Westport Development

21267 Stevens Creek Boulevard

July 14, 2020

Project Revisions

DENSITY BONUS AND WAIVER REQUESTS (CMC 19.56)

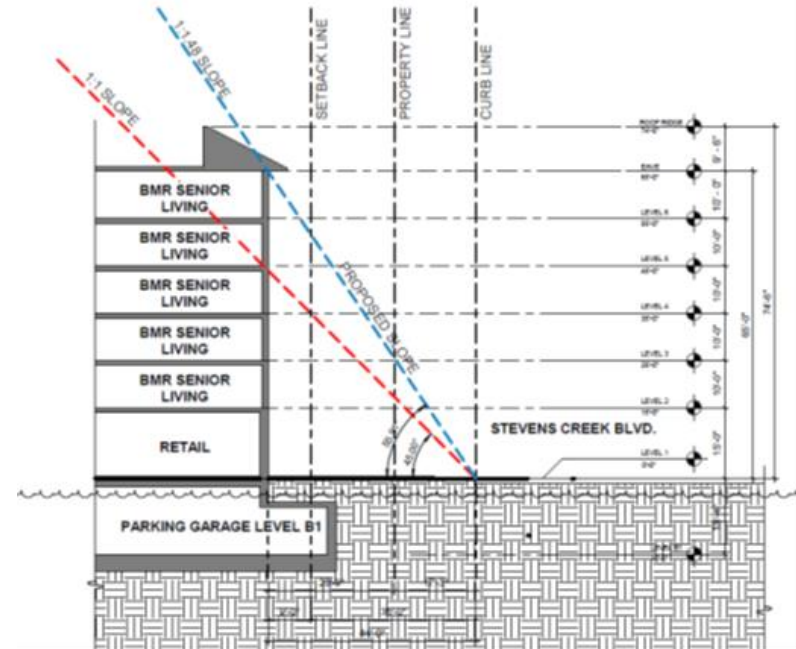
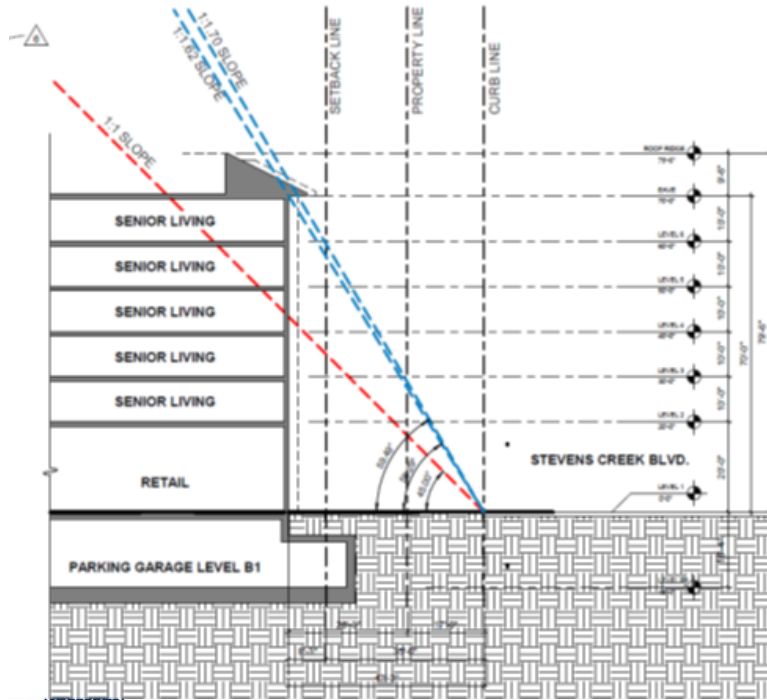
- Height waivers of 45 ft. height limit in the General Plan:
 - Building 1 would be 70' 0" to the eave line, and 79' 6" to the roof ridge.
 - Building 2 would be 65' to the eave line, and 74' 6" to the roof ridge.
- Slope setback waivers of 1:1 slope setback from curb line in General Plan to slope setback of 1:1.70 for Building 1 and a slope setback of 1:1.48 for Building 2.
- Waiver from requirement in Section 19.56.050.G.1 that affordable units be dispersed throughout the project.

<i>Allowed/Required</i>		As Presented on May 12, 2020	Revised Senior Enhanced Project
Height of Structures	Up to 45 feet	Building 1 – 91.75 feet	79.5 feet
		Building 2 – 73.75 feet	74.5 feet
		Townhomes – 30 feet	No Change
		Rowhouses – 30 feet	No Change
Slope Line Setback	1:1	Building 1- 1:2.08	1:1.70
		Building 2 – 1:1.47	1:1.48

Building 1: Revisions

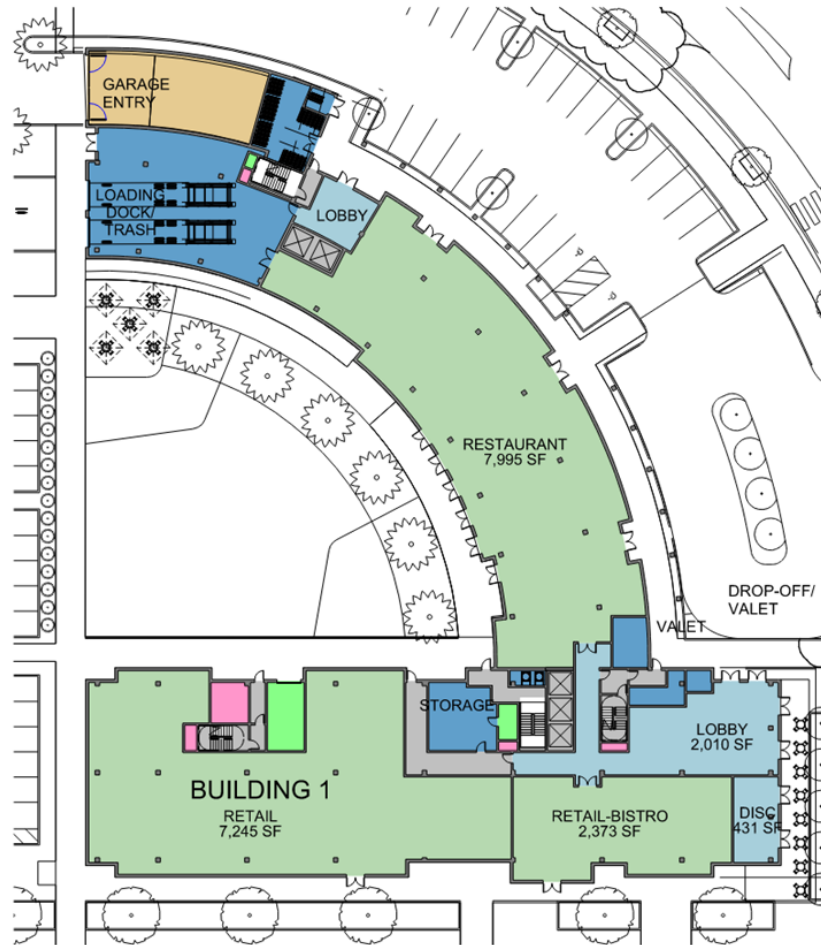
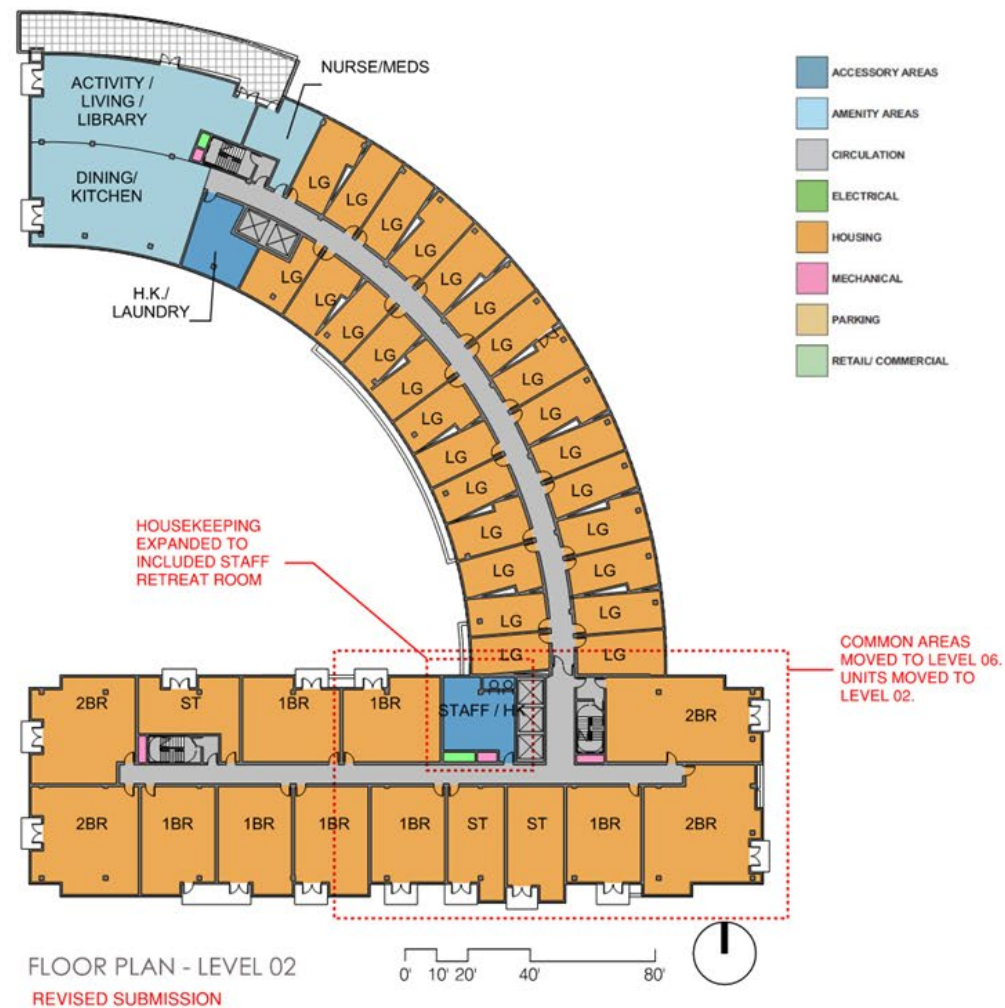
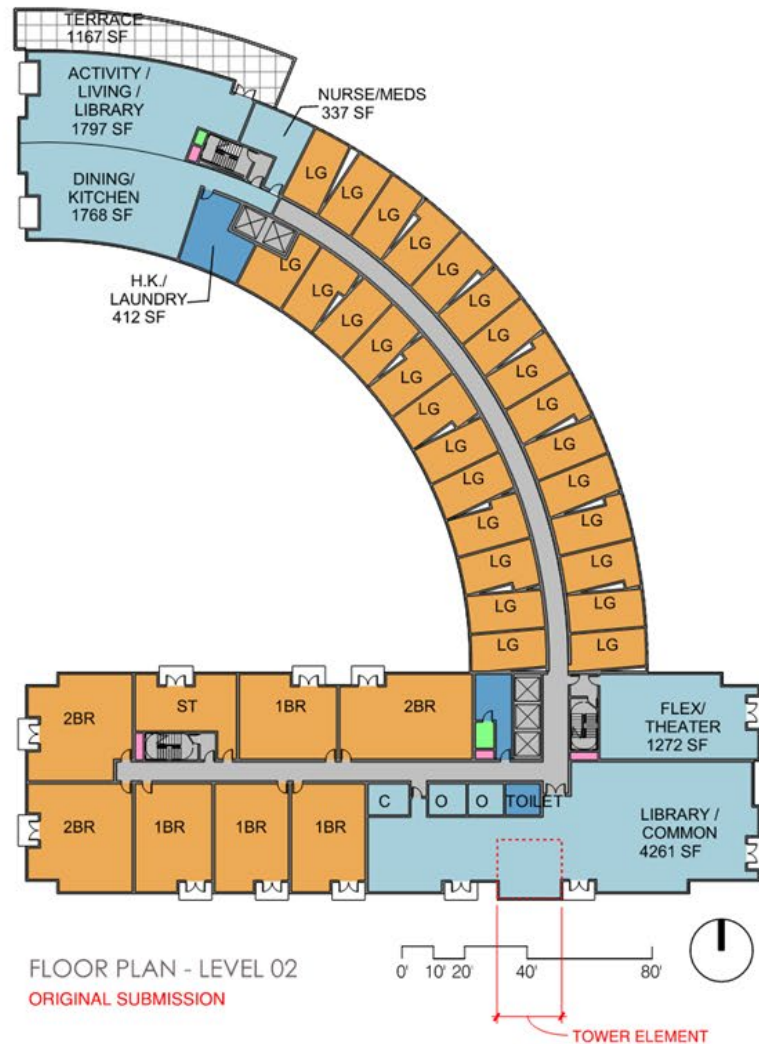
FLOOR PLAN - LEVEL 01
ORIGINAL SUBMISSION

FLOOR PLAN - LEVEL 02
REVISED SUBMISSION - NO CHANGE

Building 1: Revisions

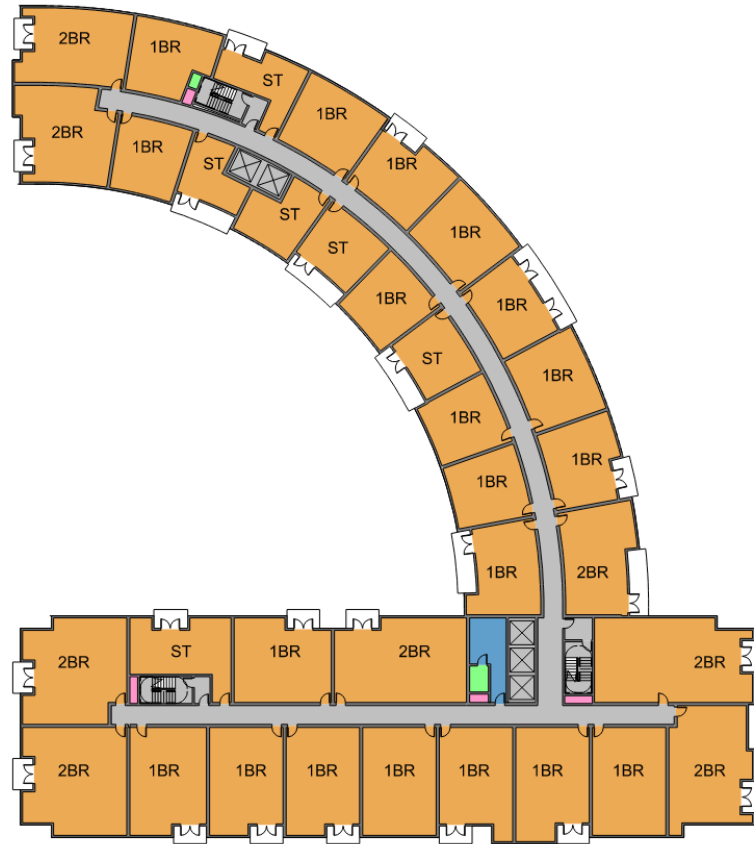
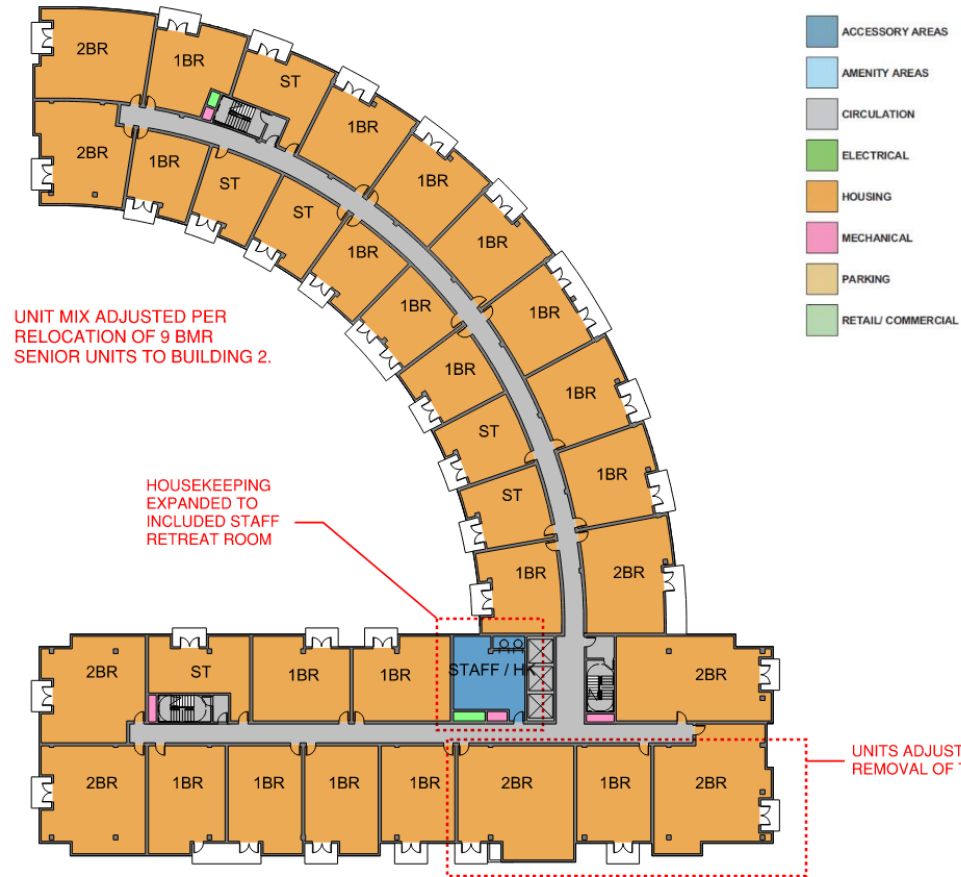
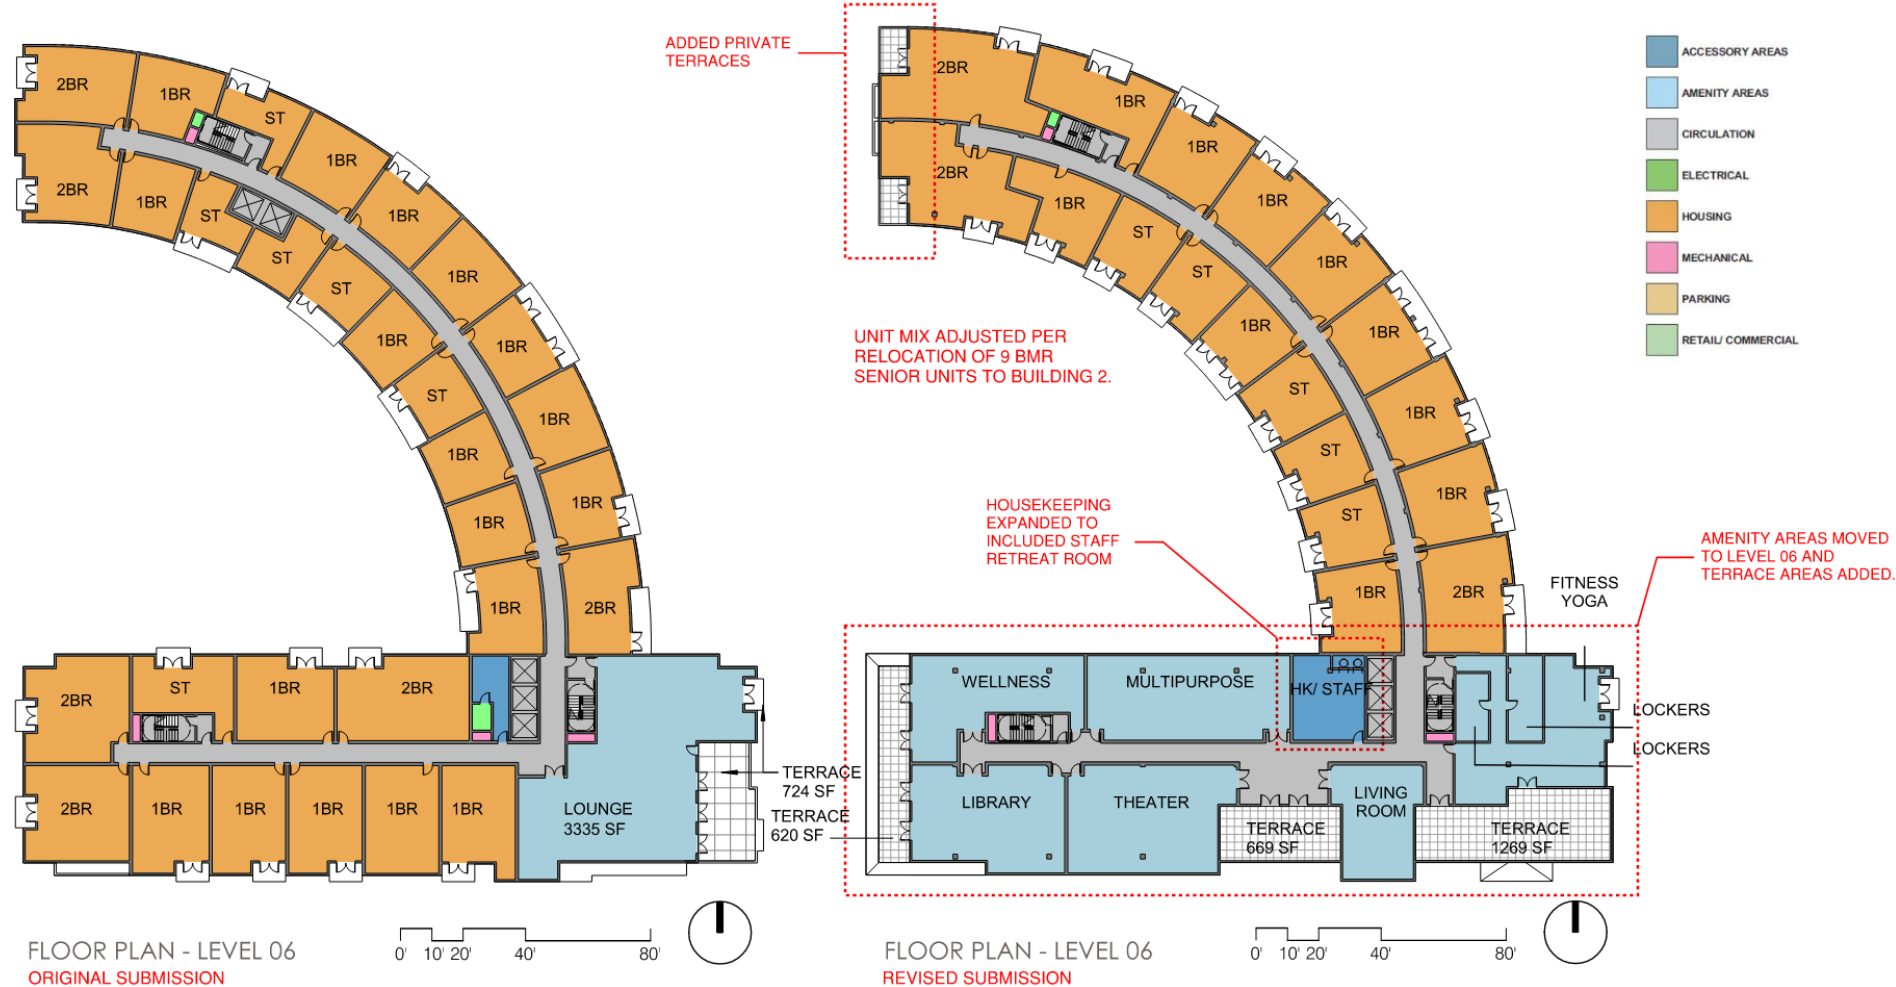
FLOOR PLAN - LEVEL 03-05
ORIGINAL SUBMISSION

FLOOR PLAN - LEVEL 03-05
REVISED SUBMISSION

Building 2:

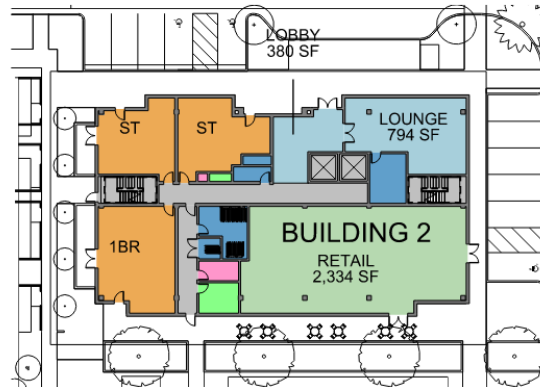
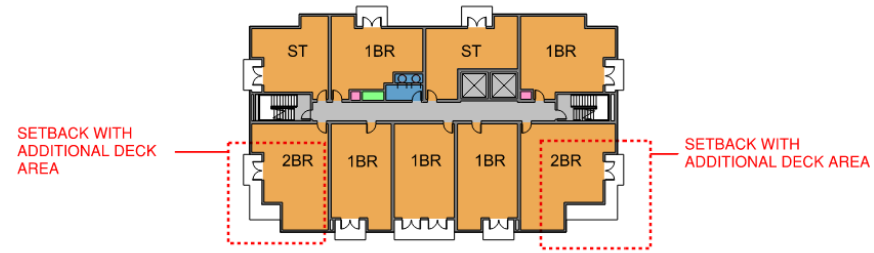
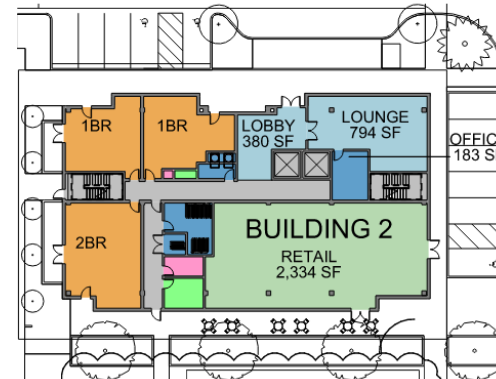
FLOOR PLAN - LEVEL 01
ORIGINAL SUBMISSION

FLOOR PLAN - LEVEL 06
ADDED FLOOR FOR RELOCATED BMR UNITS

MIX UPDATED
PER
OPERATOR
SIZING OF
UNITS /
PARITY WITH
BLDG 1

FLOOR PLAN - LEVEL 01
REVISED SUBMISSION

Building 1: Slope Section

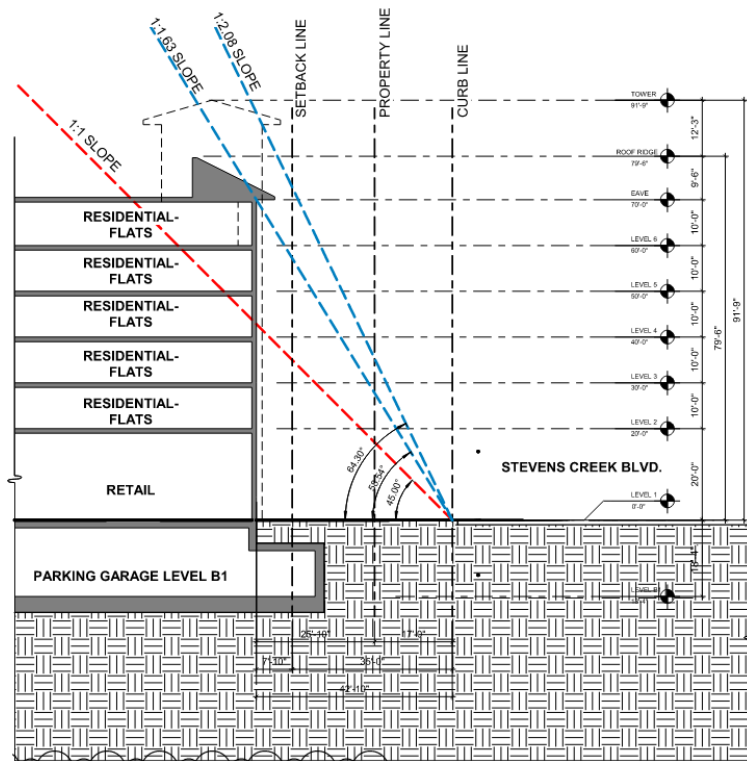
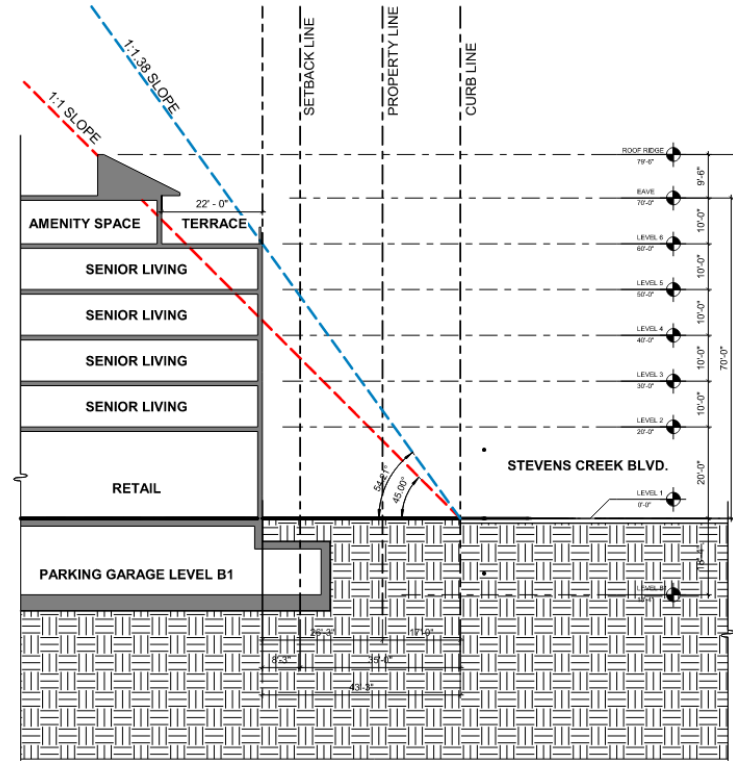
STEVENS CREEK BOULEVARD: PREVIOUS SECTION

STEVENS CREEK BOULEVARD: PROPOSED SECTION
AT TERRACES

Building 1: Slope Section

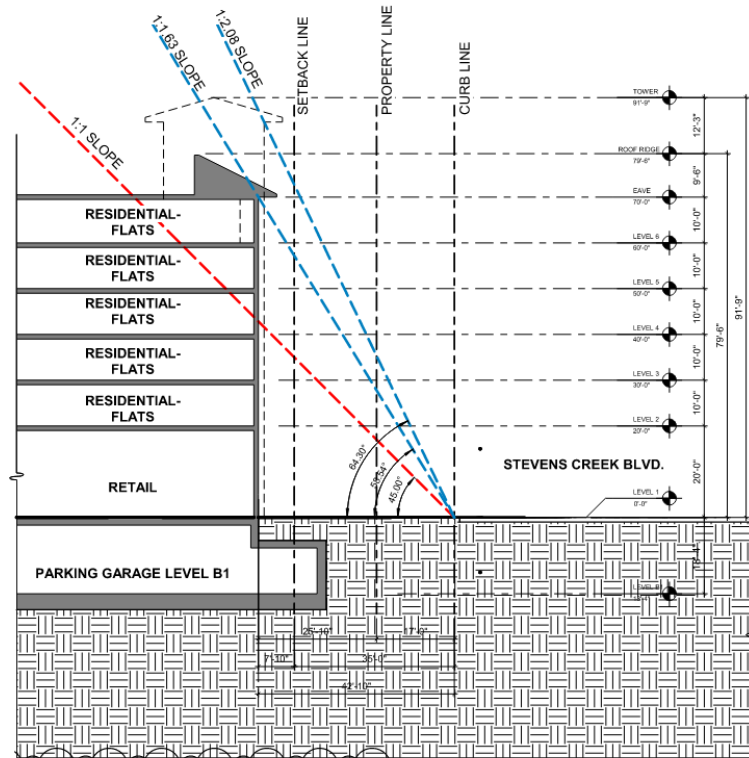
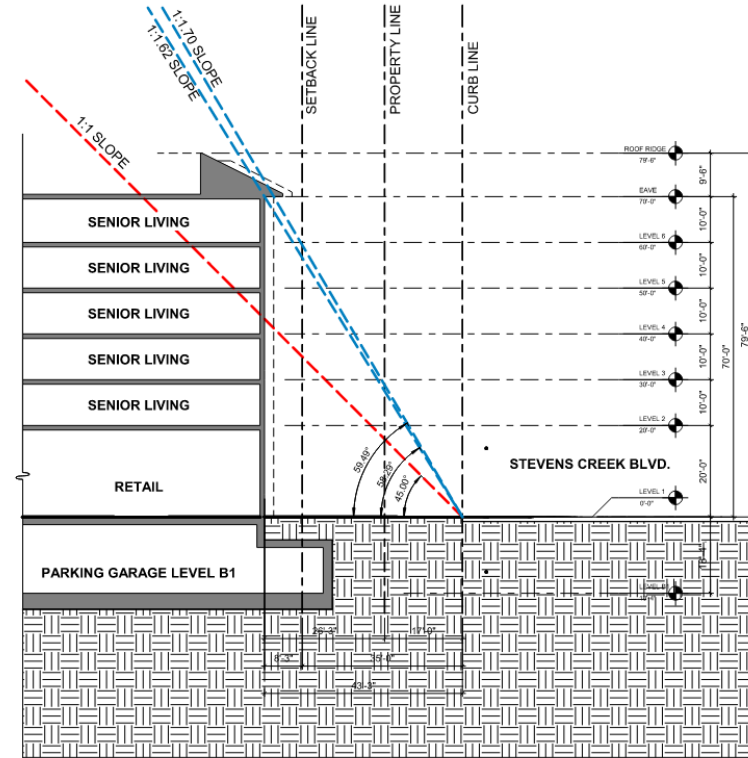
STEVENS CREEK BOULEVARD: PREVIOUS SECTION

STEVENS CREEK BOULEVARD: PROPOSED SECTION

Building 2: Slope Section

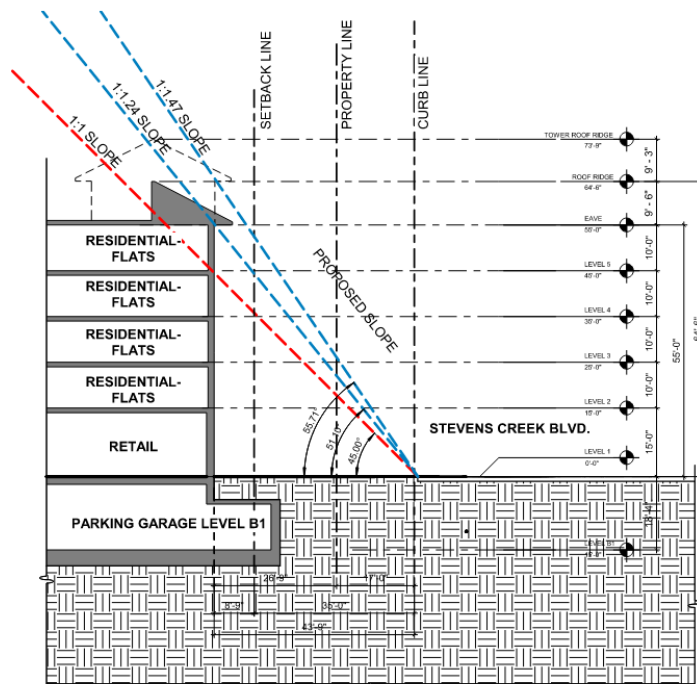
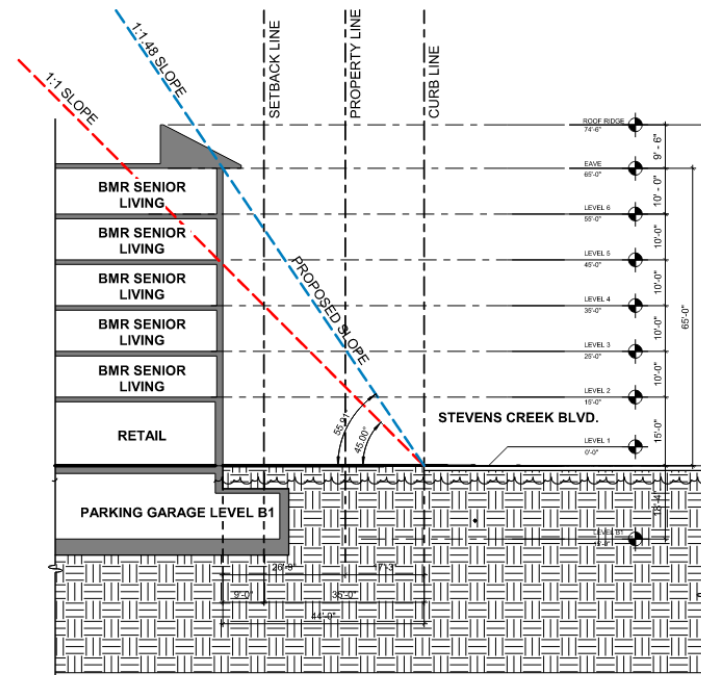
STEVENS CREEK BOULEVARD: PREVIOUS SECTION

STEVENS CREEK BOULEVARD: PROPOSED SECTION
